# Summerhill Residents Association

19 February 2025

## 1212-1220 Yonge Street: Proposed Zoning By-Law Amendment

Figure 7: Avenue Segment Study – Development Scenario

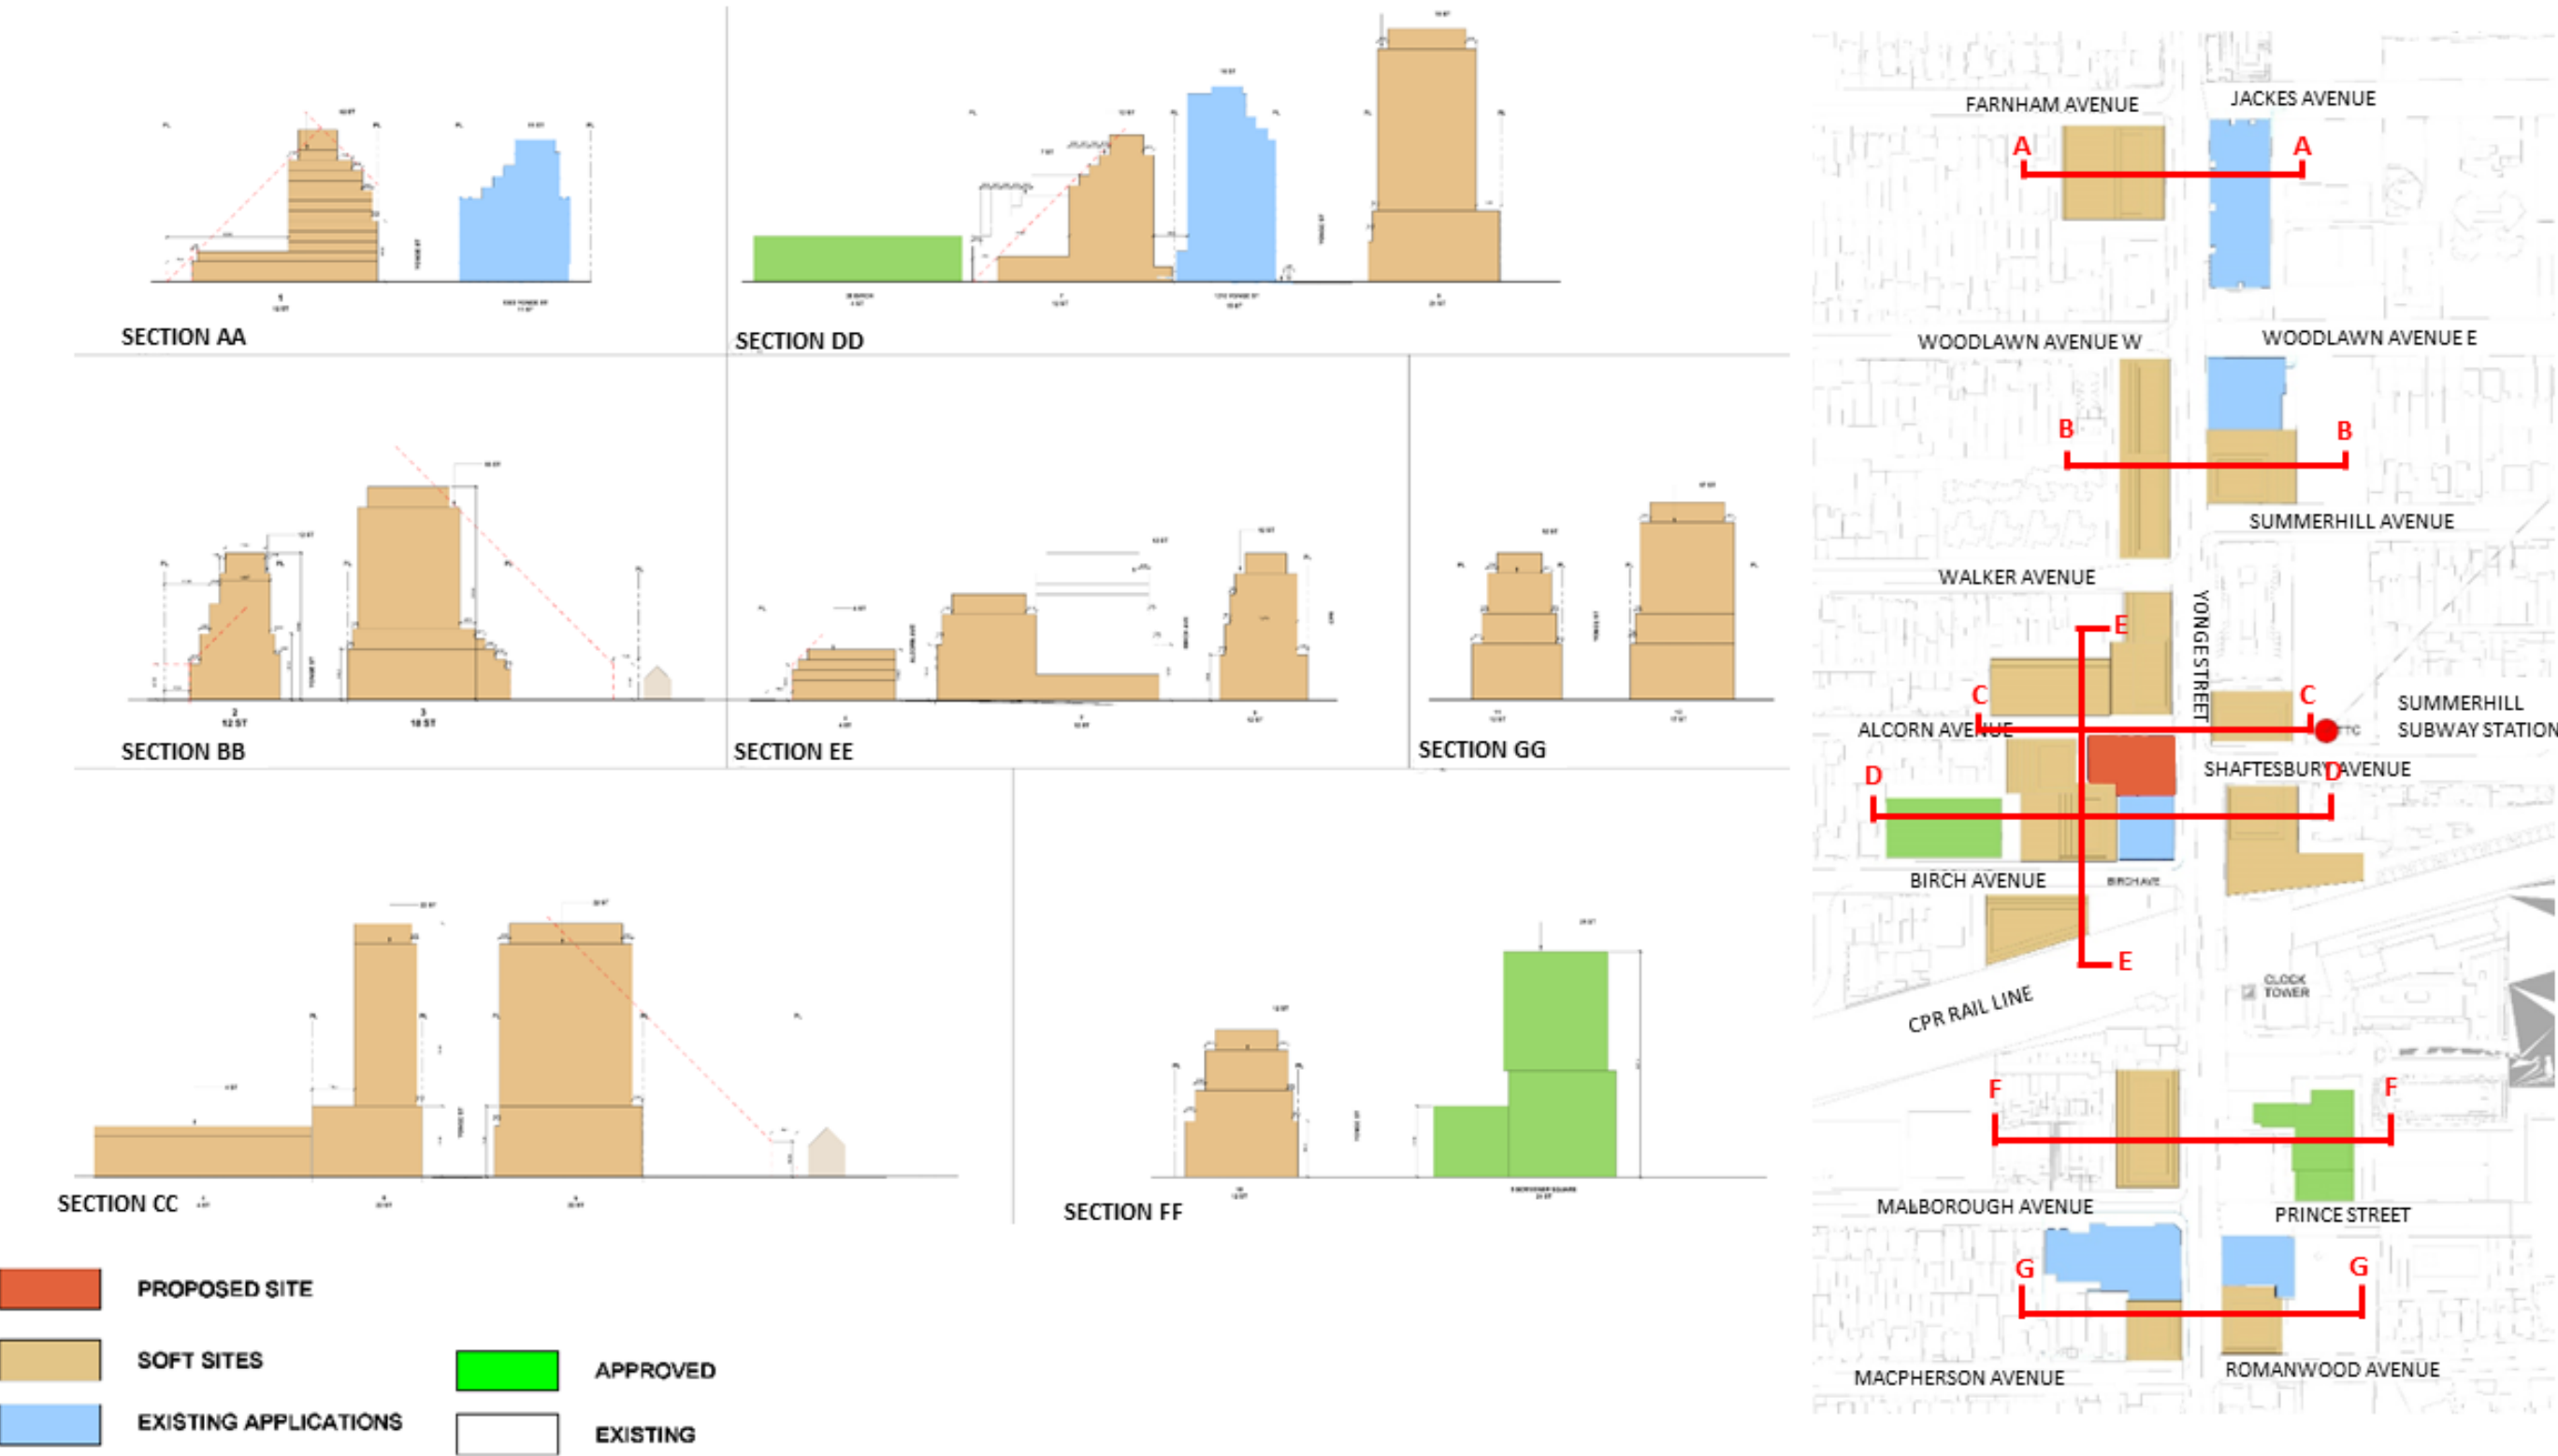
3. The *Avenue Segment Review Study* ("ASRS") submitted in support of this application is based on the lower building height and density. And, yet, it shows that the more modest development intensity would already generate in this Avenue Segment 2,225 additional residential units and a non-residential GFA of 10,914 square metres which translates into a population of 4,450 and an employment of 364.
